# AVIATION RESPONSE TO SUBMISSIONS IN RELATION TO AVIATION REPORT SUPPORTING TWEED VALLEY HOSPITAL STAGE 2: SSD-10353 APPLICATION

# STATE SIGNIFICANT DEVELOPMENT AVIATION REPORT TWEED VALLEY HOSPITAL STAGE 2: SSD-10353

Image 3: Flight path illustration at TVH HLS

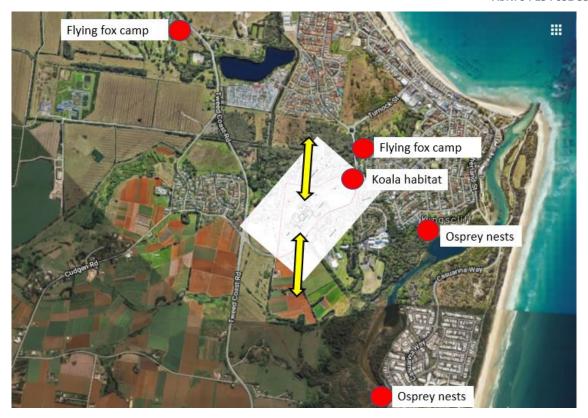
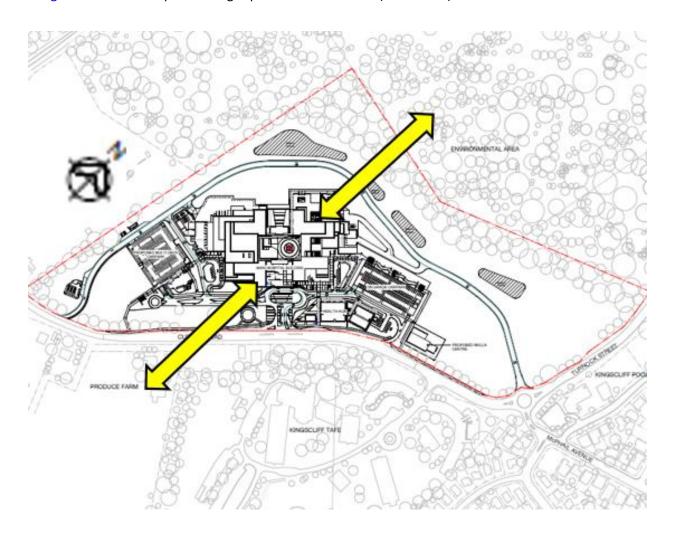
1. Biodiversity and Conservation Department (BCD) Item 6a: Revise the AviPro report to consider other potential locations for flying fox camps, as identified in the Tweed and through discussions with Tweed Shire Council and wildlife carer organisation operations in the region, such as the Elrond Drive, Chinderah flying fox camp, be thoroughly investigated to ensure that if present the risk to these camps will also be considered for the helicopter operations.

Department of Planning, Infrastructure and Environment (DPIE) Item 16: The submitted
 Aviation assessment must be updated to consider the impacts of the helicopter movements on
 potential locations for flying fox camps surrounding the site.

<u>AviPro Response:</u> The Report has been amended to reflect known areas of sensitive fauna as per the Biodiversity Development Assessment Report (BDAR). Additional areas identified to AviPro from now on can be included in a final review of approach and departure paths prior to completion of HLS survey and commencement of HLS construction. The revised Aviation Report (V1.4) dated 19 Nov 2019 contains more information.

Helicopters flying northbound (typically flying to Gold Coast Hospital/Brisbane) will either climb to altitude out of TVH, turn to track west and pick up the western VFR route (see the purple dotted line on Image 2) or track east for the coast. This will normally be the case regardless of whether the helicopter takes off to the north or the south. Rarely will they fly near either flying fox camp. Helicopters flying southbound (typically returning to Lismore) will either continue southbound if taking off to the south or will turn to the south soon after departure if taking off to the north. Rarely will they come close to the Elrond Dve, Chinderah flying fox camp.
